## DG340/R-3.81 Amendment Notice

Date: 03/21/2016'

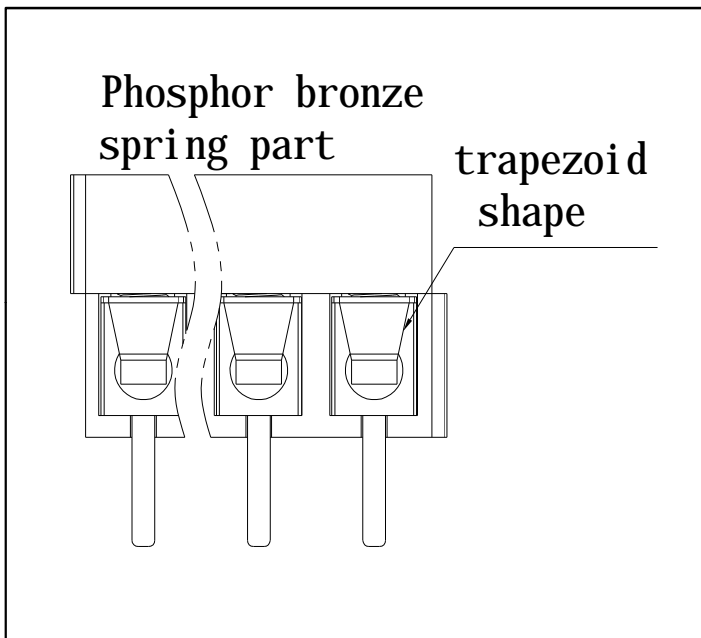
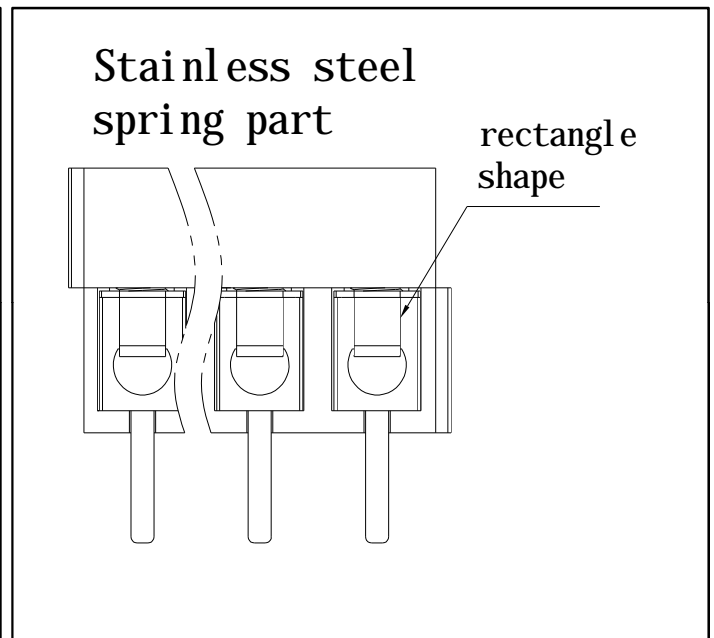
**Amendment Items:** Changing spring part material from phosphor bronze to stainless steel, the structure change to cater for our automatic machine.

**Explanations:** For our DG340/R-3.81 series product, we change its spring part material from phosphor bronze to stainless steel, it can optimize product performance, structure change in order to cater for automatic machine, it can improve product quality.
